BULLETIN NO. 33

JEFFERSON LAB

TECHNICAL ENGINEERING & DEVELOPMENT FACILITY
(TEDF TWO)

Bulletin No.33
Project No. 20080400
March 04, 2011

EWING COLE

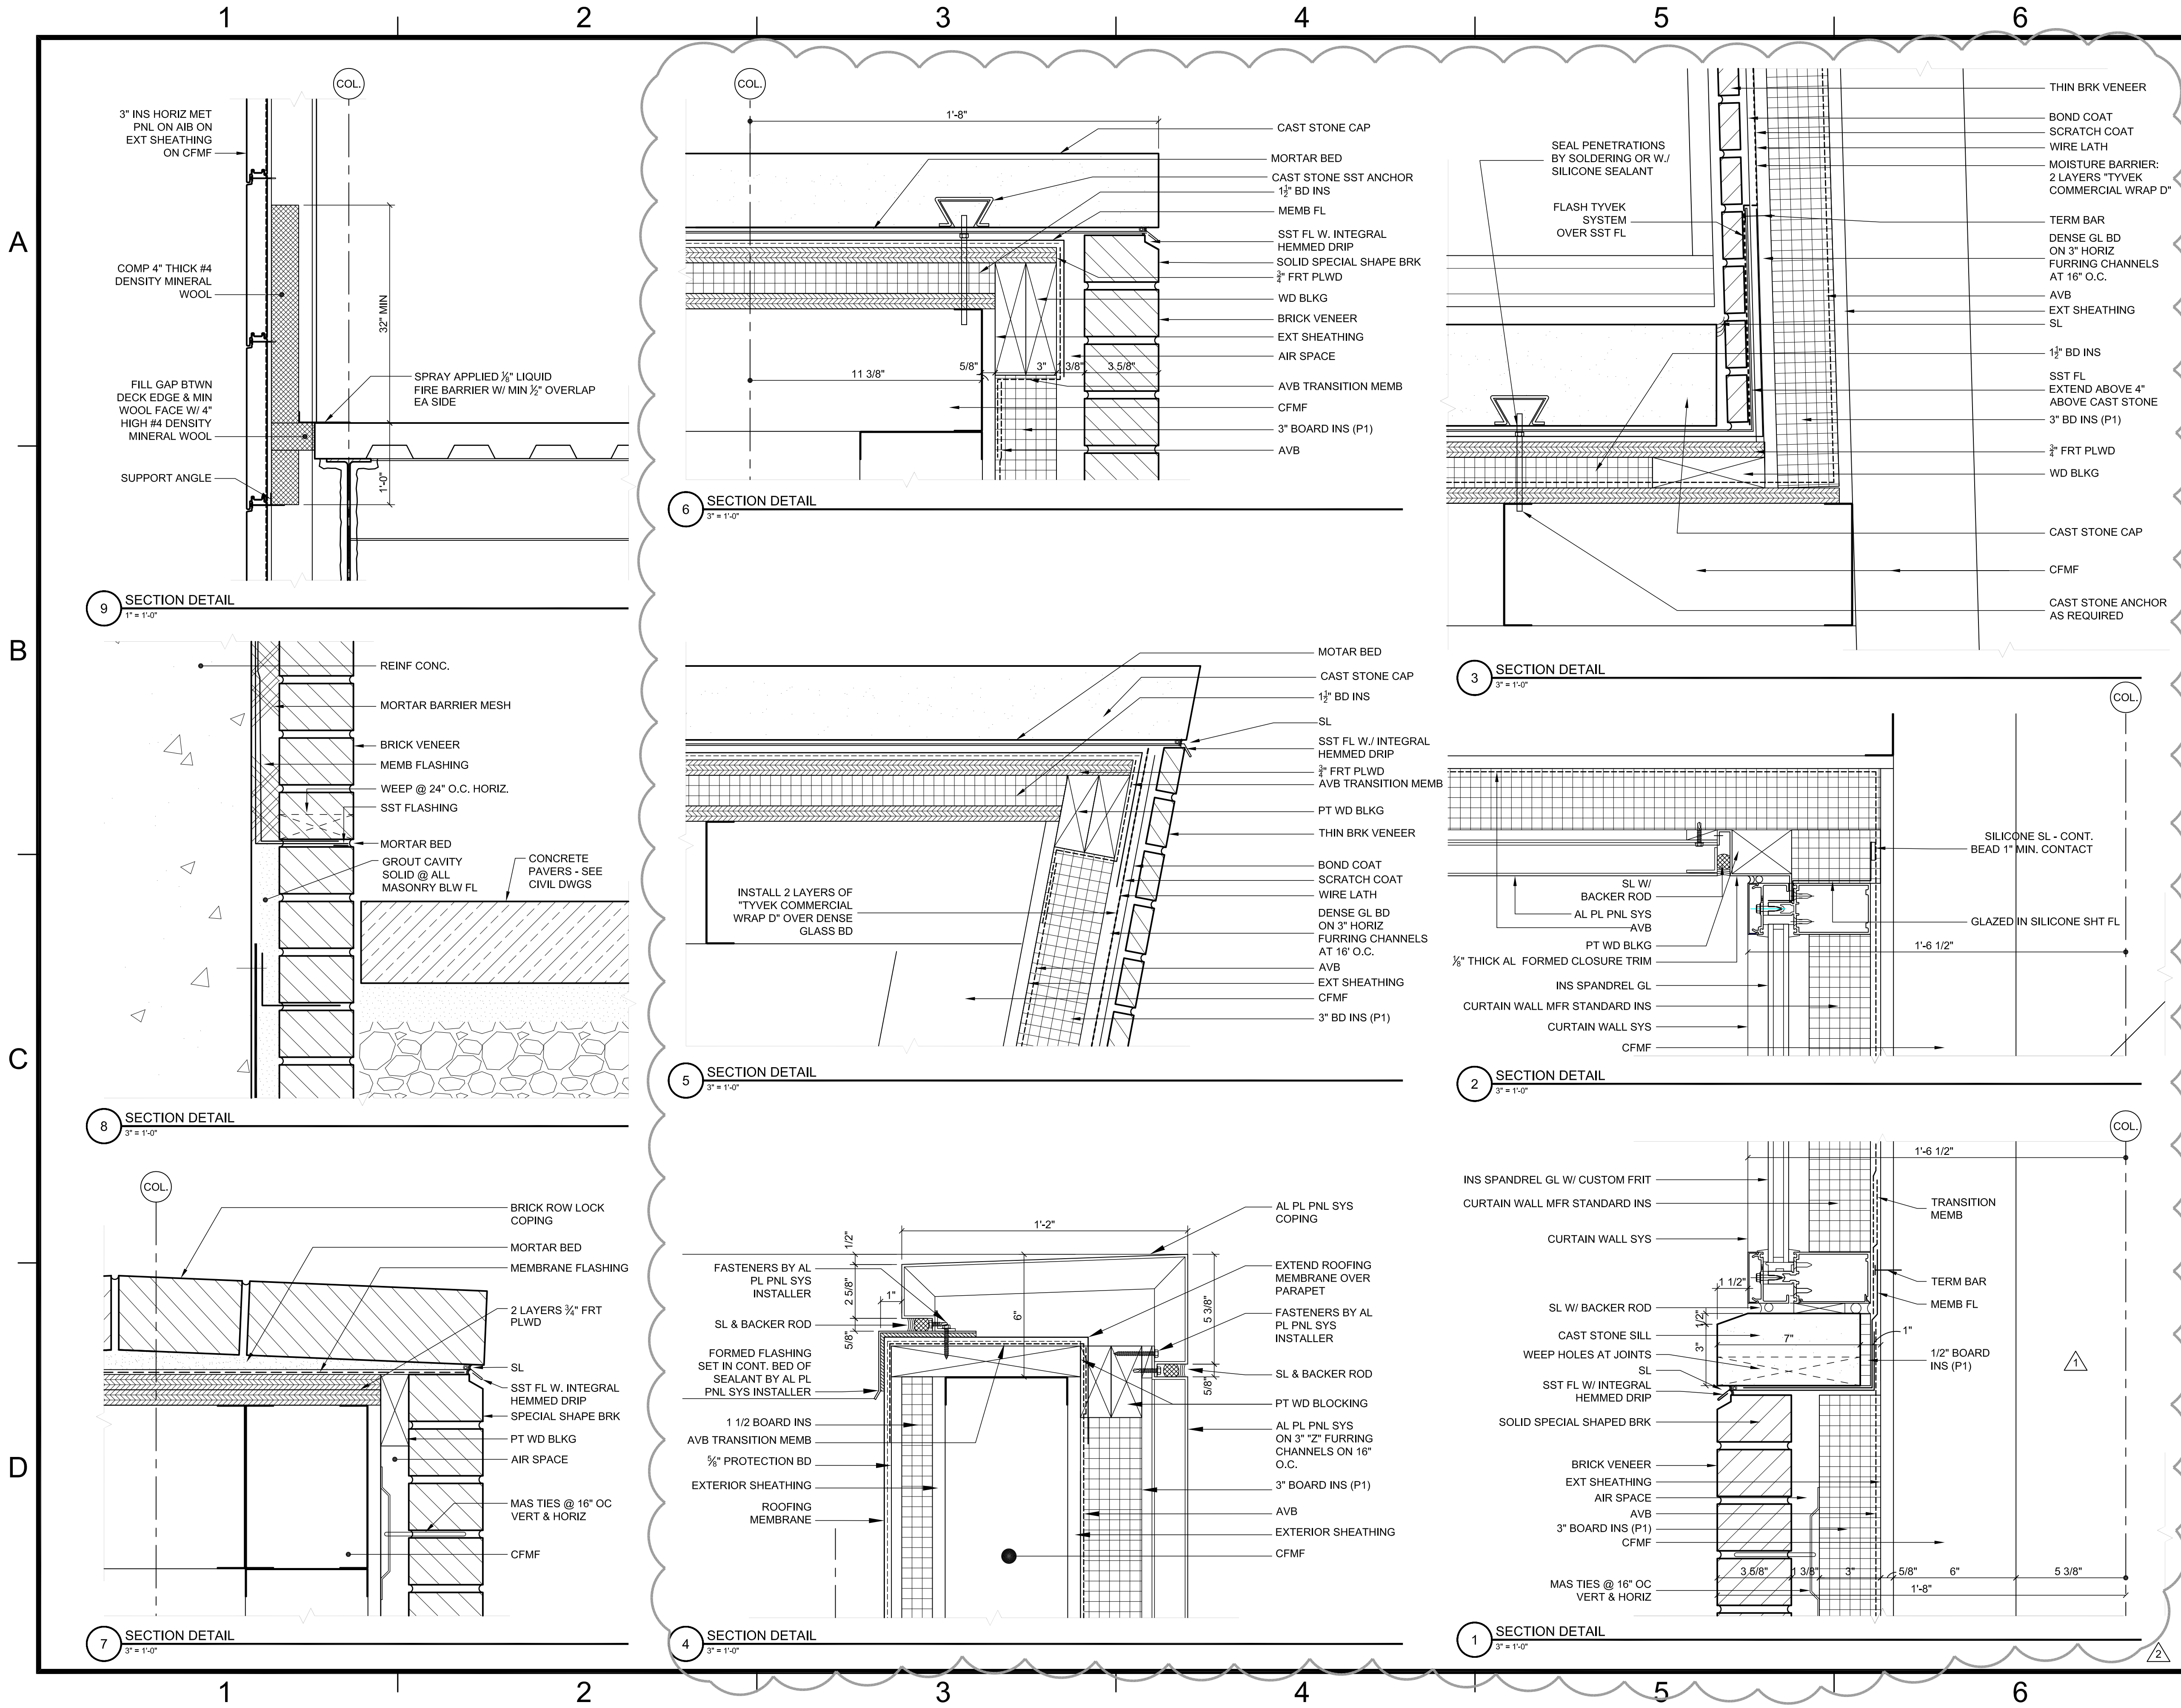
1. Revised section details

SCALE	DRAWING NUMBER	SHEET	REV
AS NOTED	100024-182-A164-STE	TED-A3.2.4.5	-

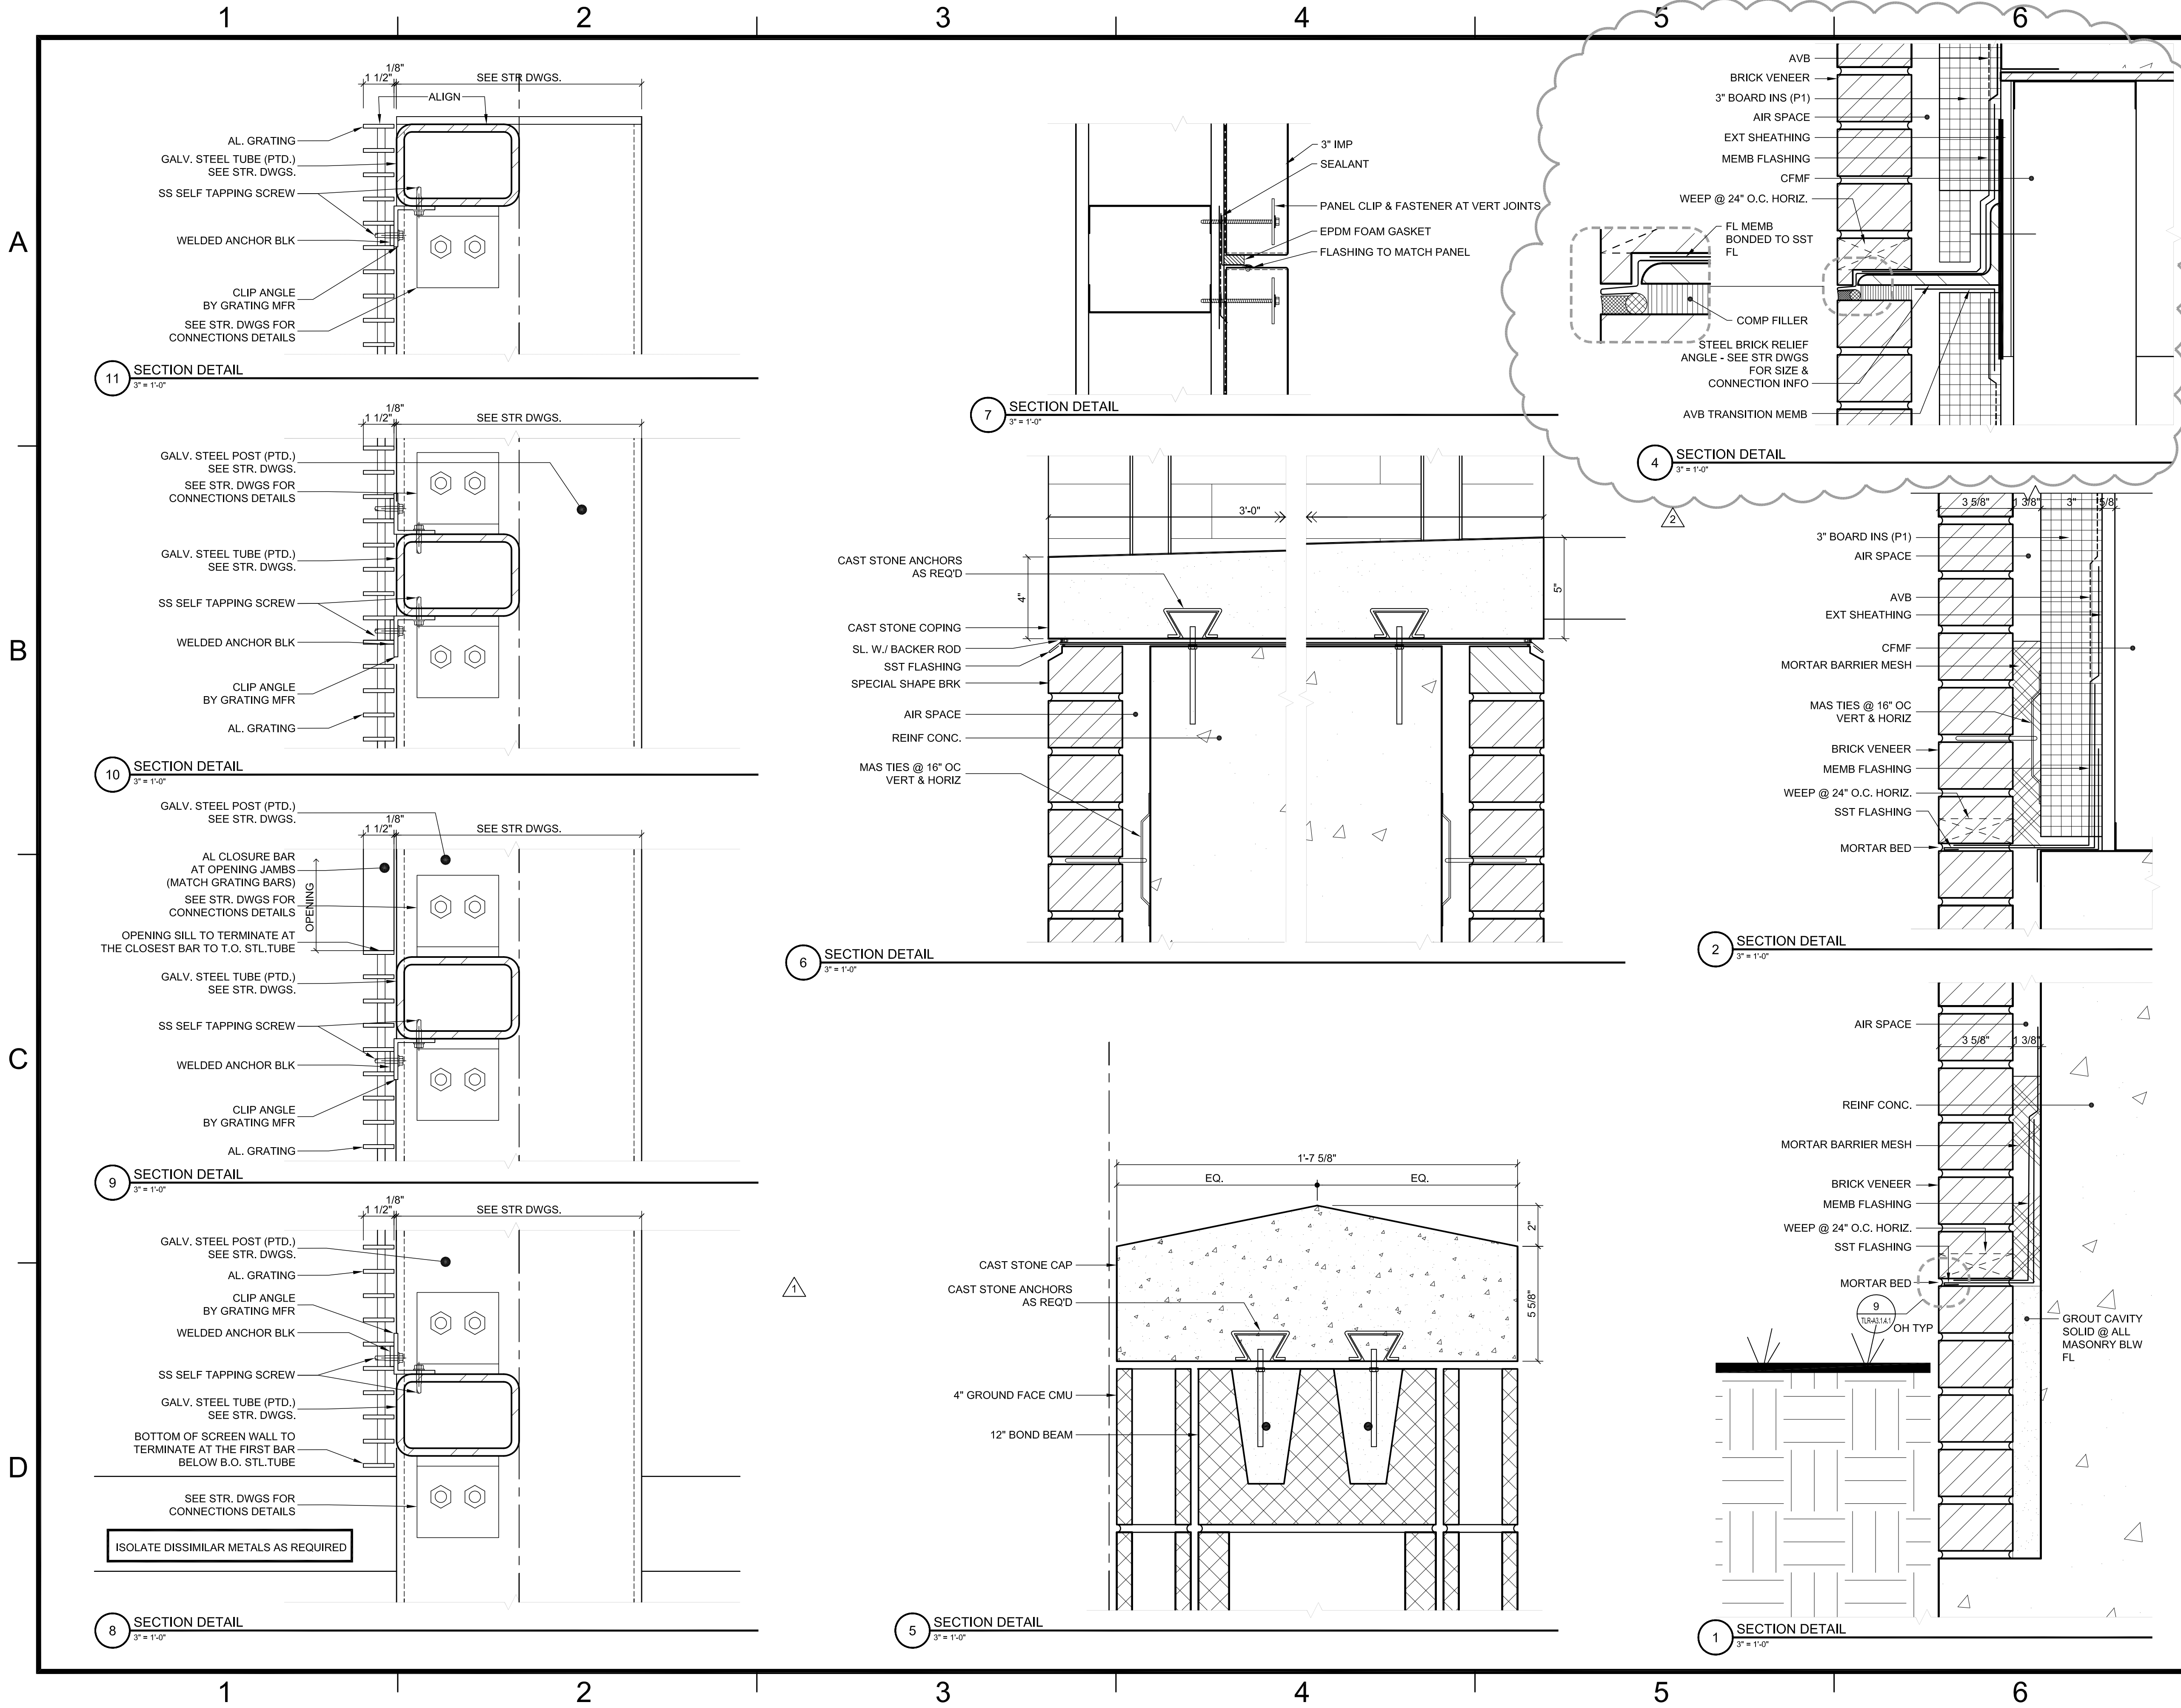
1. Revised section details
